Addendum No. 2
October 16, 2023

Project: **Harrisburg South Middle School Theatre Addition**
Harrisburg, South Dakota
Architecture Incorporated Project #3024

Scope of this Addendum:

Sheet Contents **FLOOR PLAN - AREA A - VENTILATION & A/C**

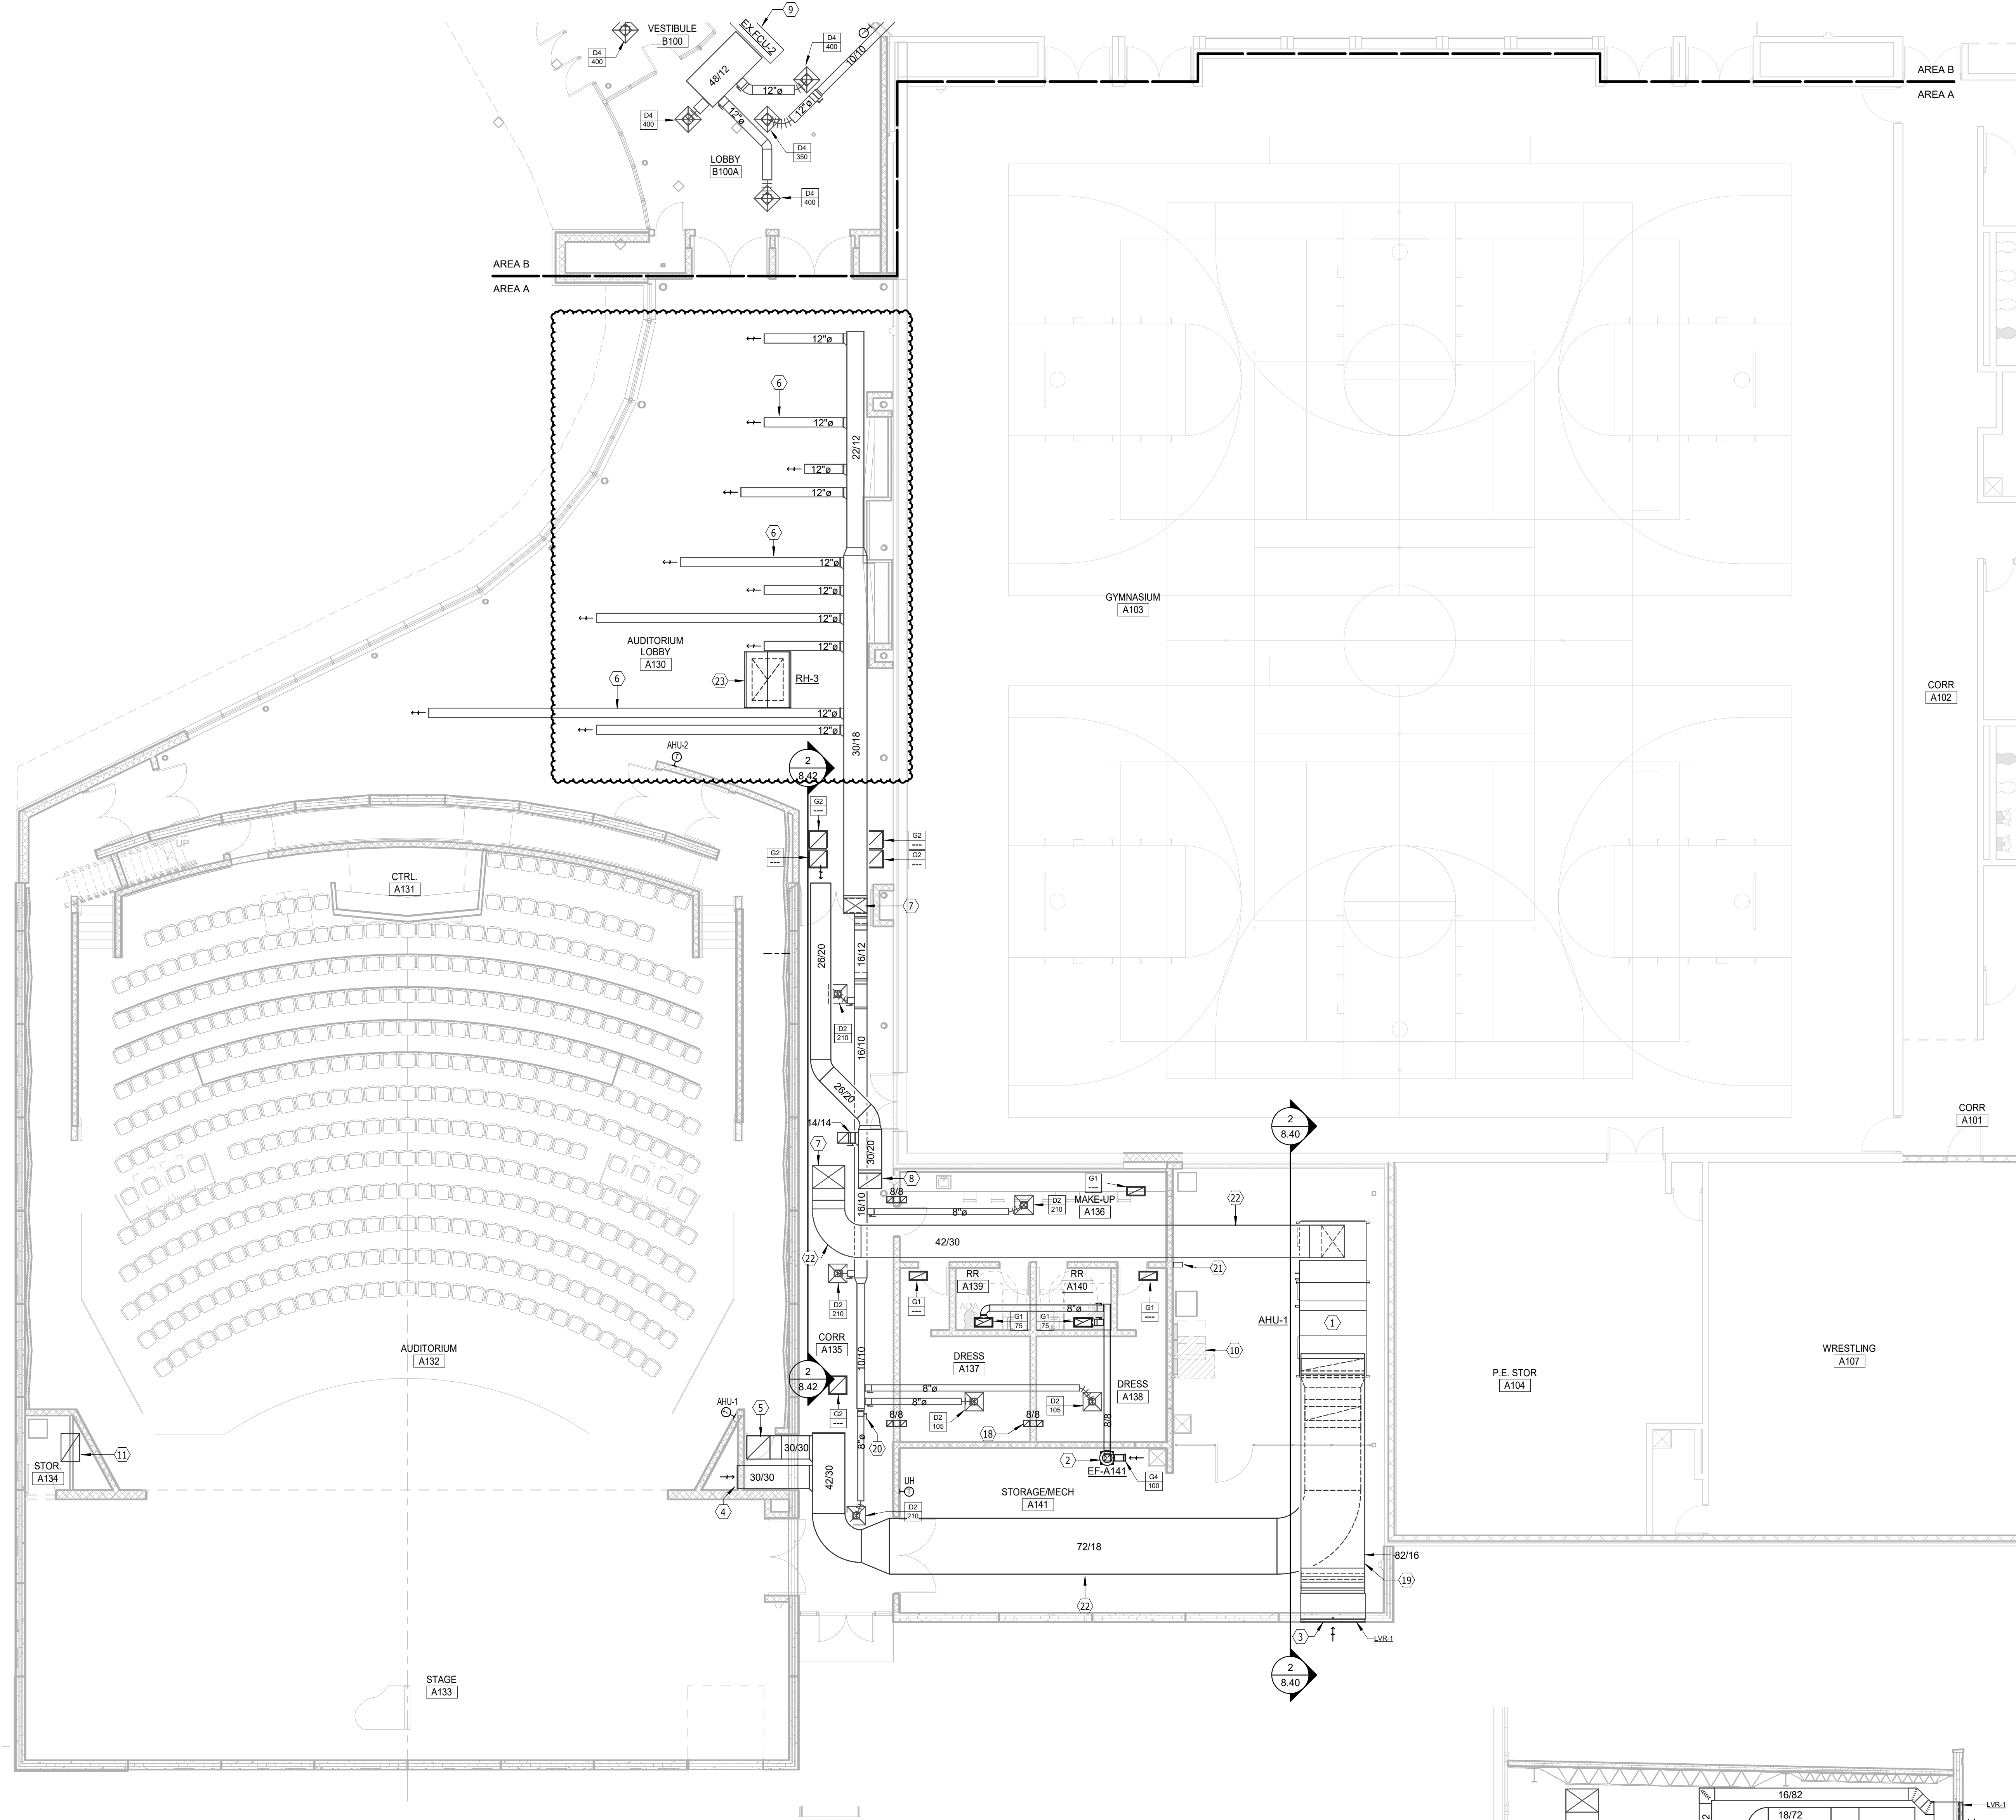
- 9) 8.40 – FLOOR PLAN – AREA A – VENITLATION & A/C
 1. Modify Note 22 as shown on sheet 8.40, dated 10-16-23, Addendum #2.
 2. Add relief hood RH-3 as shown on sheet 8.40, dated 10-16-23, Addendum #2.

8.41

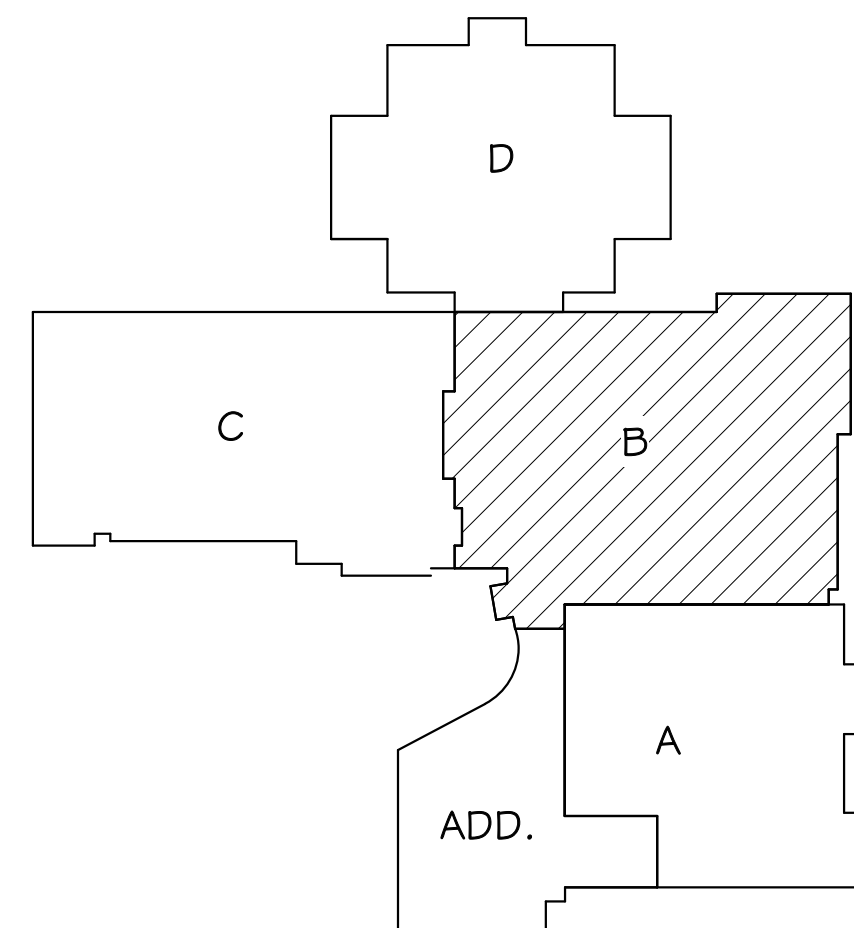
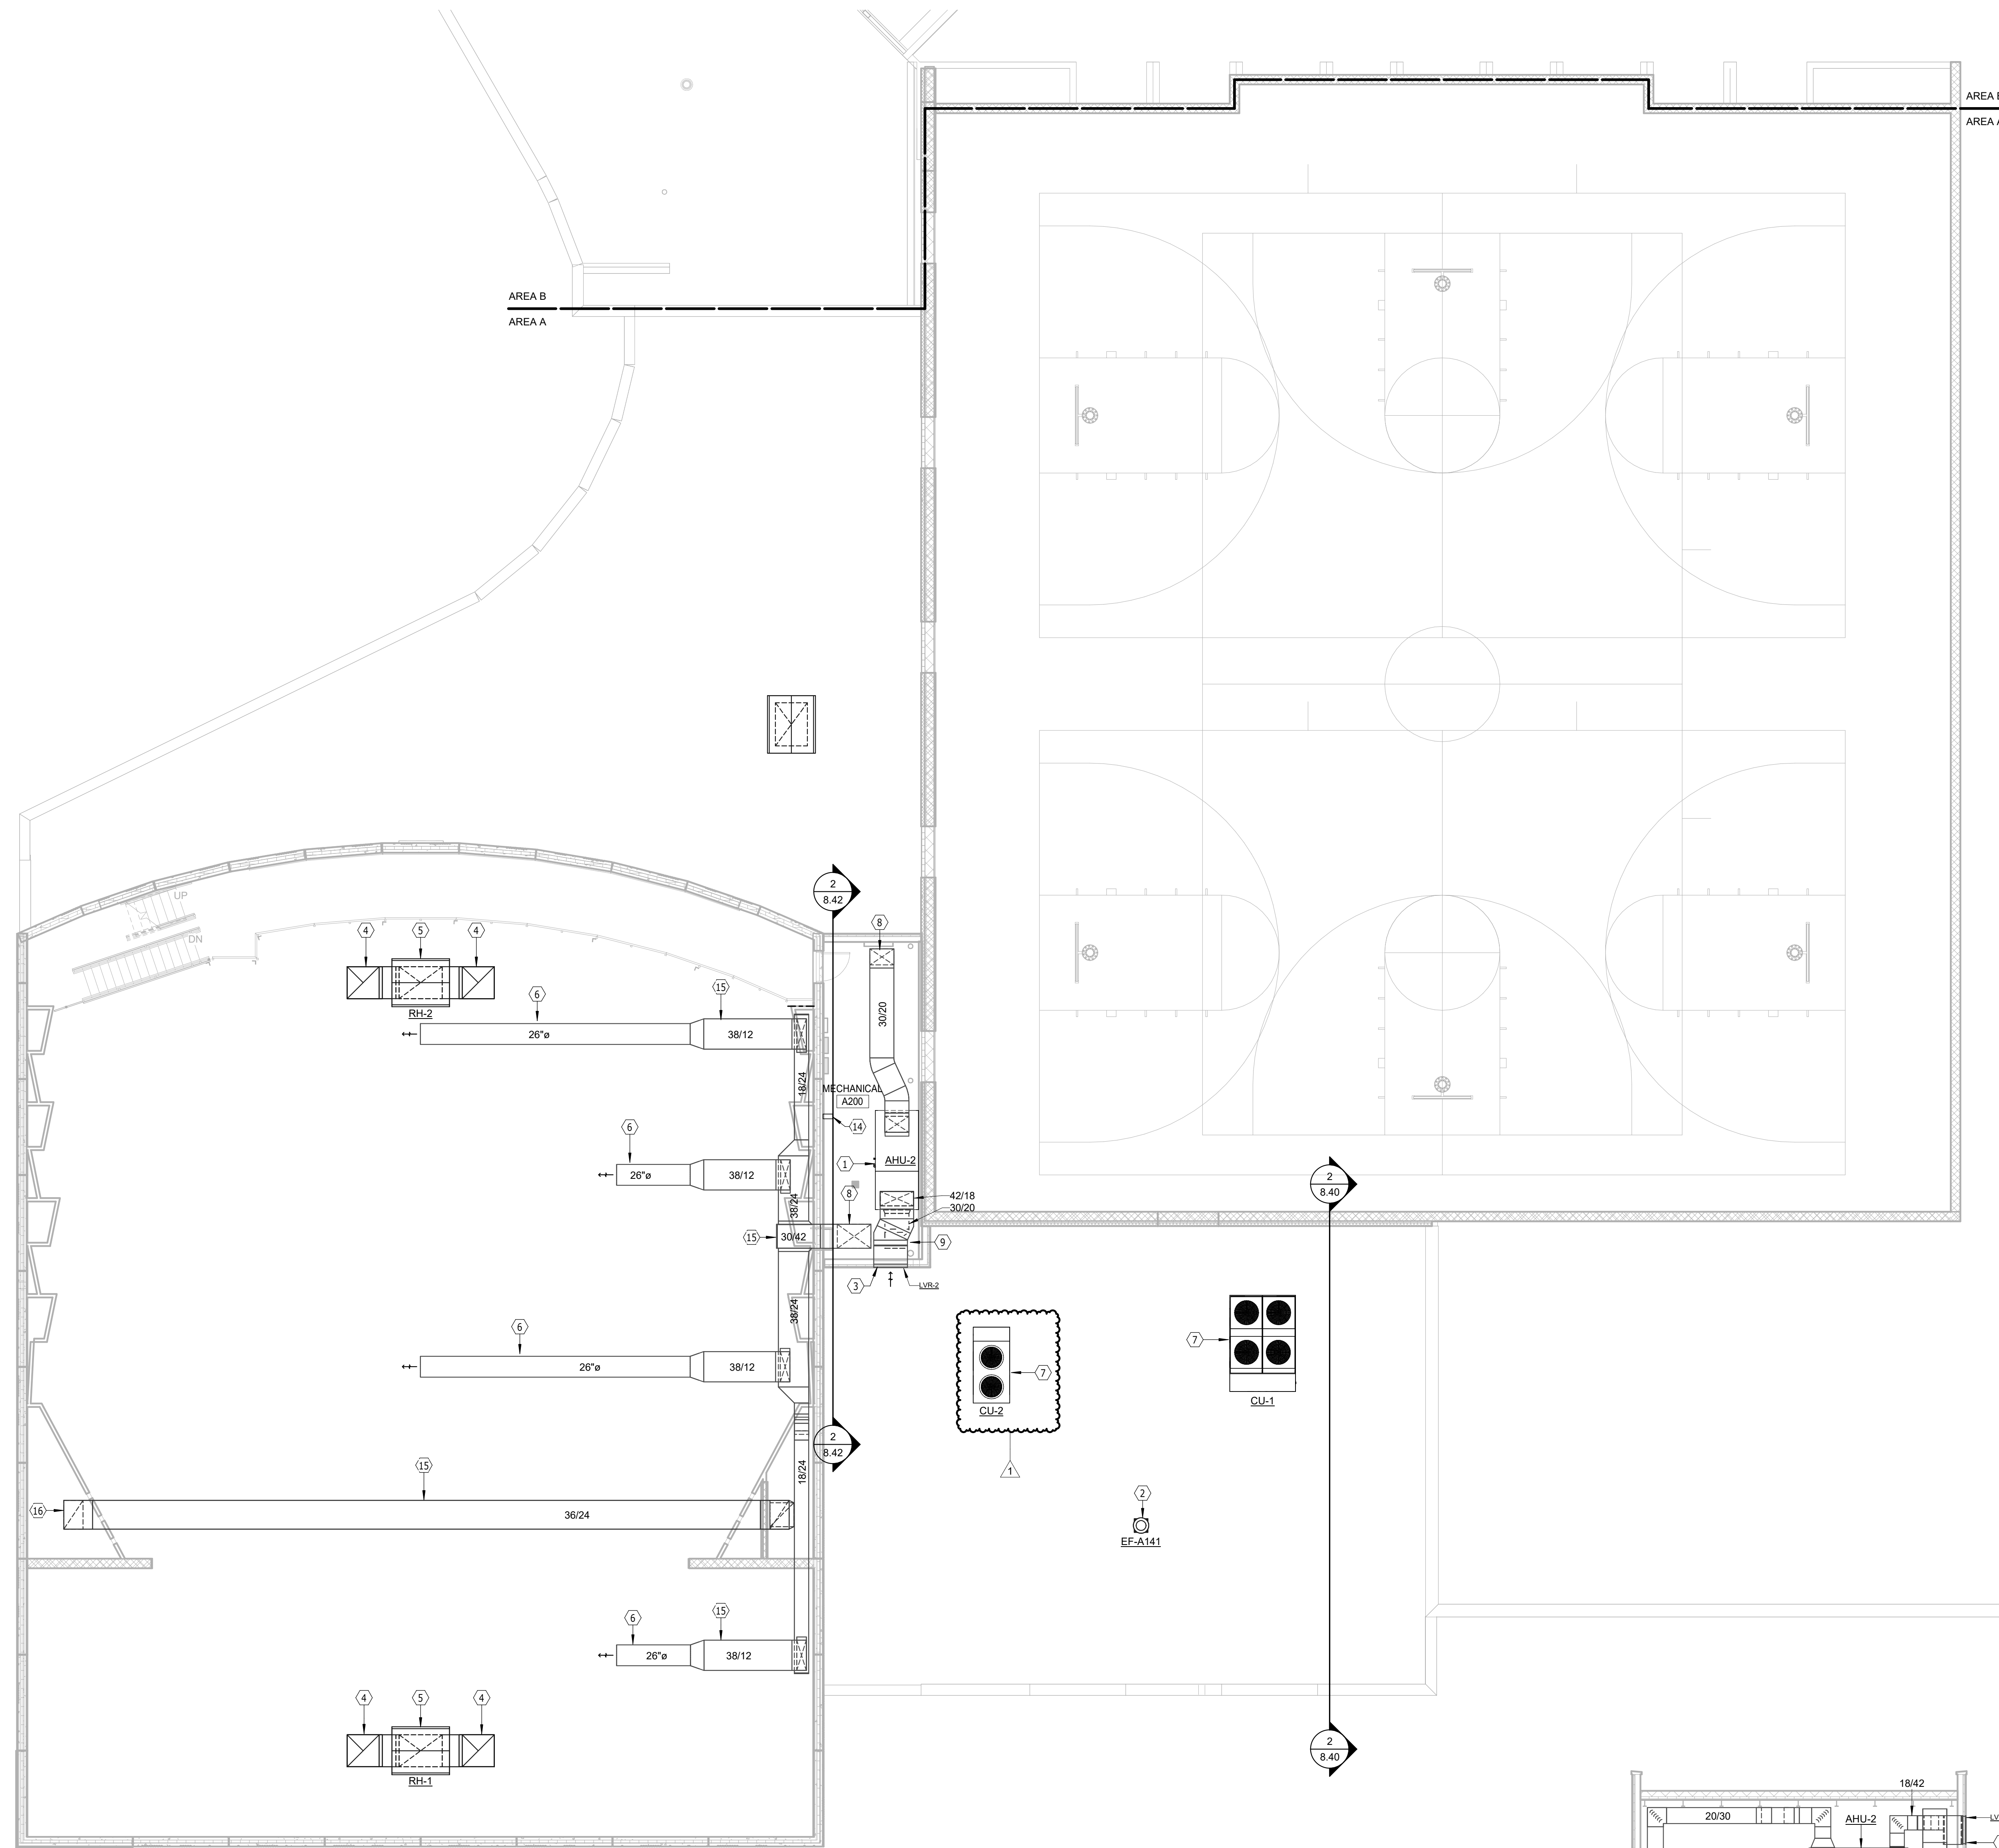
1. Replace RGDS in bathrooms B118B and B117B as shown on sheet 8.41, dated 10-16-23, Addendum #2.
- 12) 8.42 – PENTHOUSE PLAN – AREA A – VENITLATION & A/C

PENTHOUSE PLAN - VENTILATION & A/C

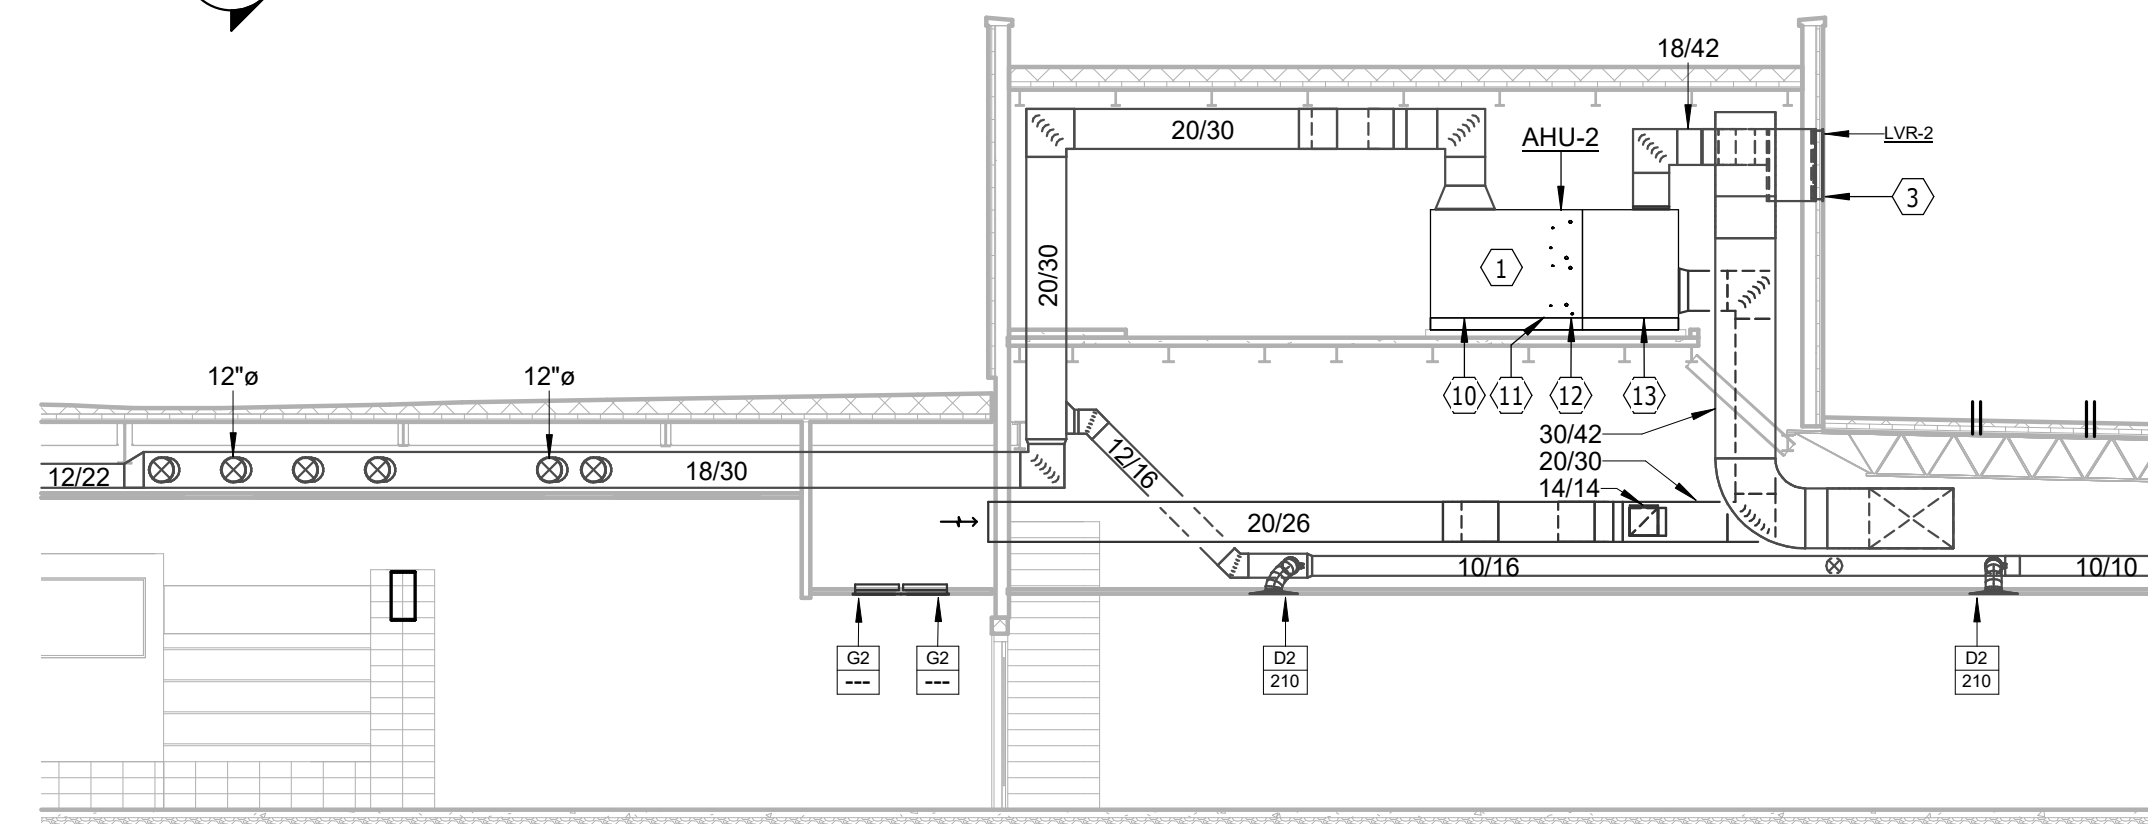
1. Relocate CU-2 as shown on sheet 8.42, dated 10-16-23, Addendum #2.
 2. Modify Note 7.
